SUBJECT: AMENDMENT NO.126 TO FACILITY OPERATING LICENSE NO. DPR-50

THREE MILE ISLAND NUCLEAR STATION, UNIT NO. 1

AMENDMENT TO FACILITY OPERATING LICENSE

Amendment No. 126
License No. DPR-50

Figure 3.5-2F

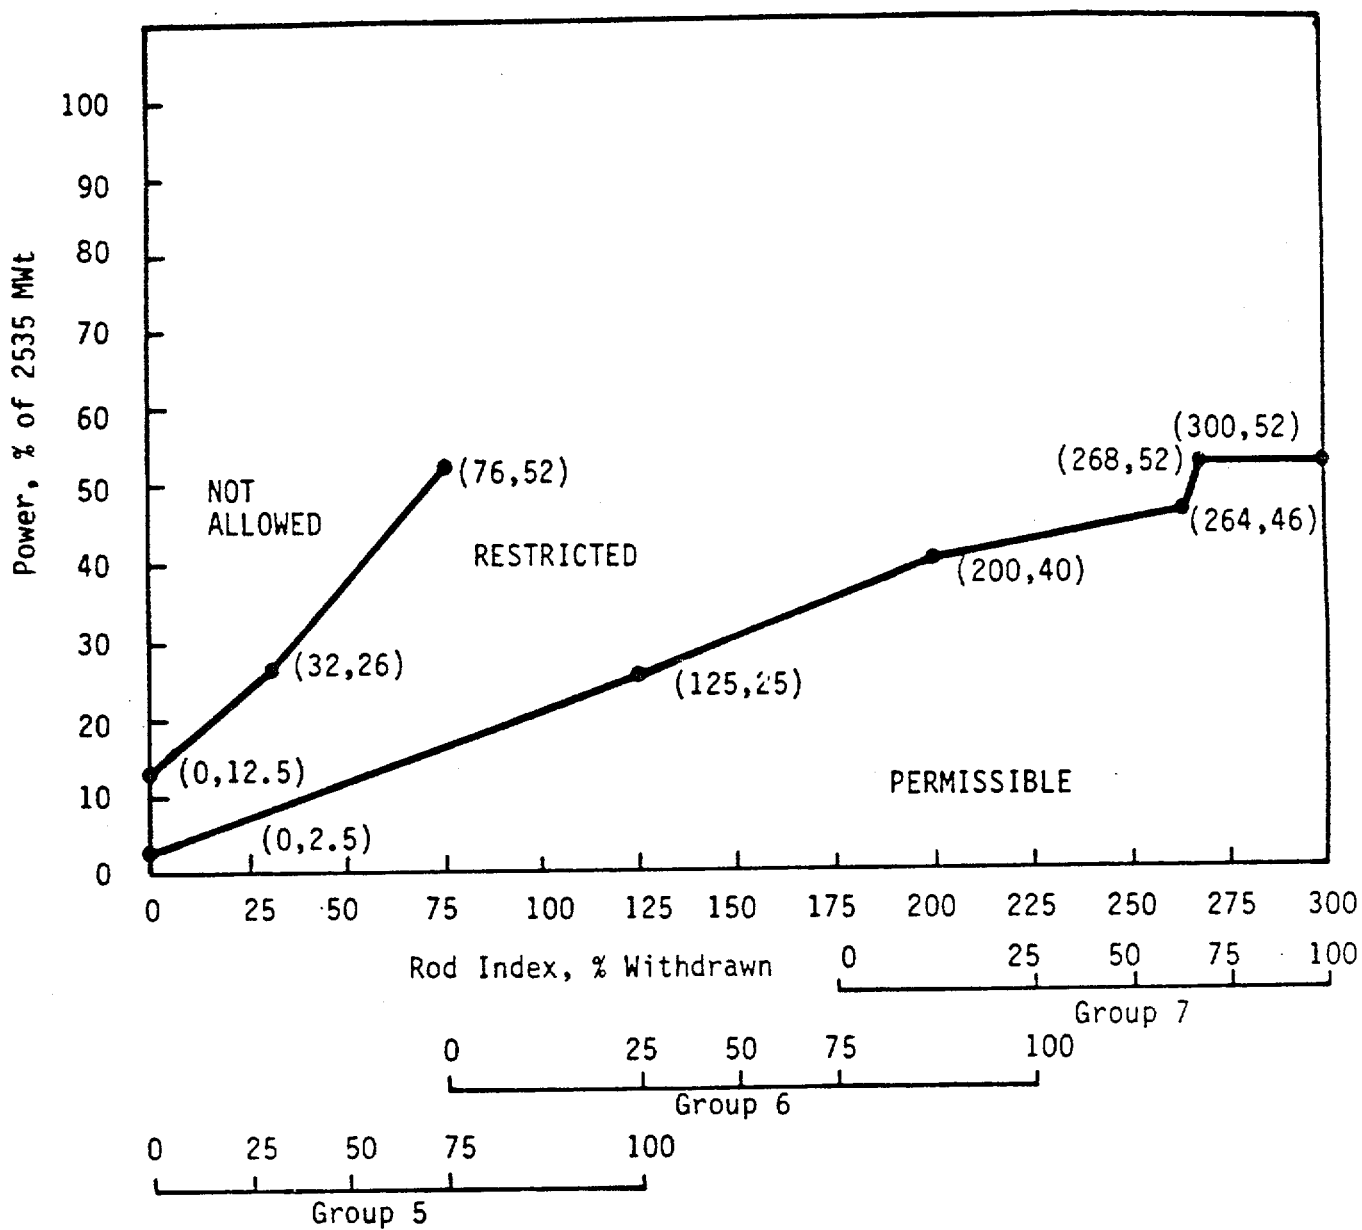
New control rod insertion limits (Figure 3.5-2A through Figure 3.5-2I) are provided for 4, 3 and 2 pump operation, as well as a function of burnup interval. These Figures are acceptable since they are based on the Cycle 6 safety analysis discussed previously.

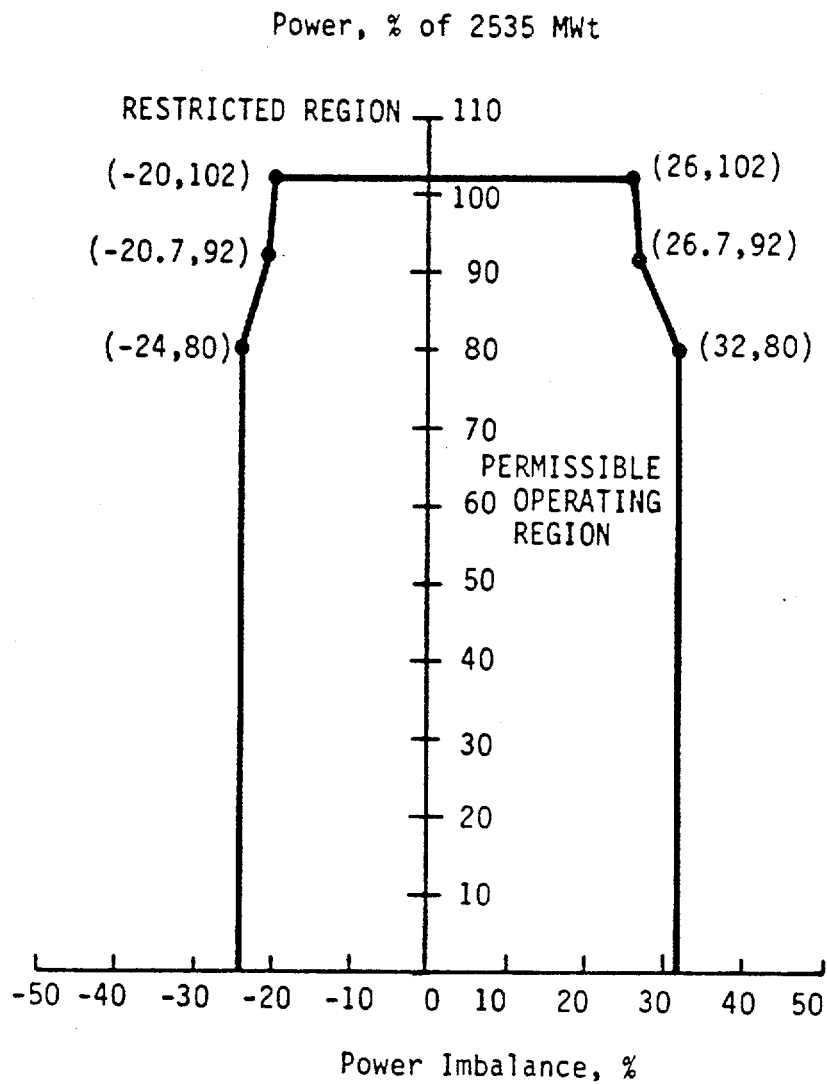
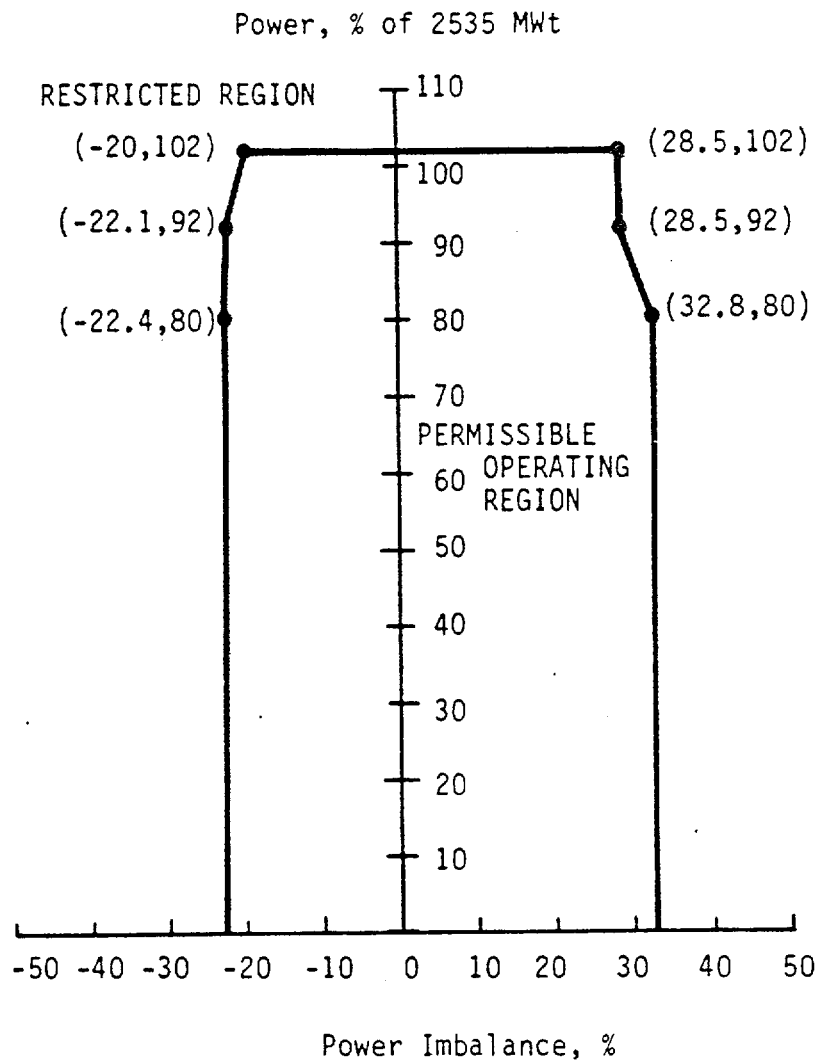
New reactor power imbalance limits (Figure 3.5-2J and Figure 3.5-2K) are provided for two different burnup intervals. These Figures are acceptable since they are based on the Cycle 6 safety analysis discussed previously.

LOCA LIMITED MAXIMUM
ALLOWABLE LINEAR HEAT RATE

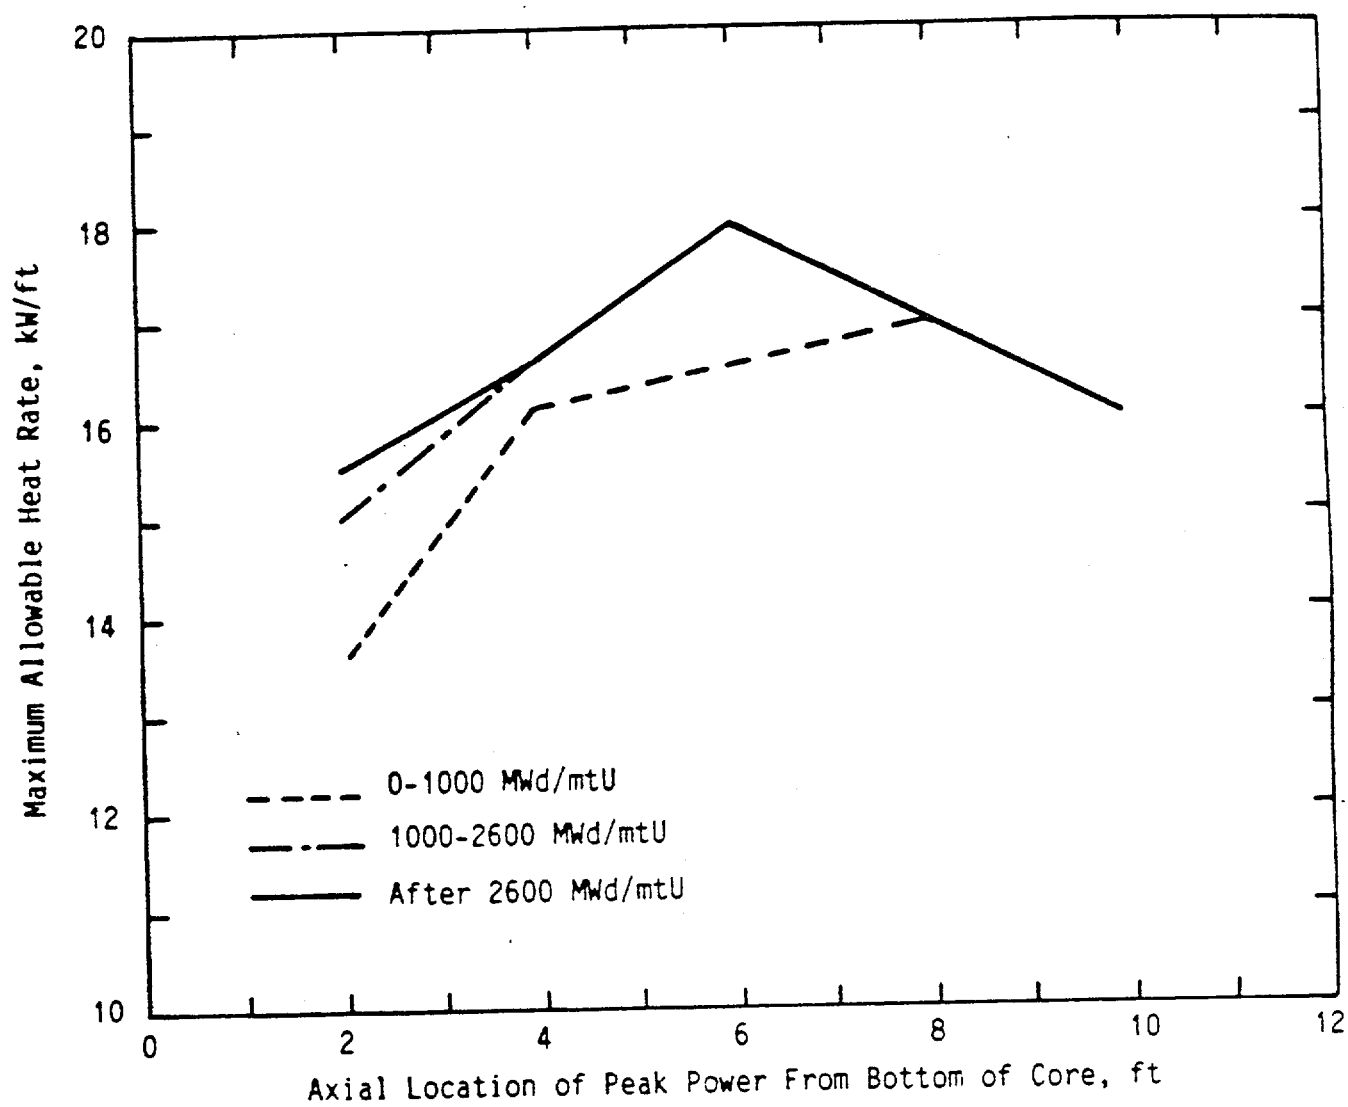
20. Figure 3.5-2L, LOCA Limited Maximum Allowable Linear Heat Generation Rate
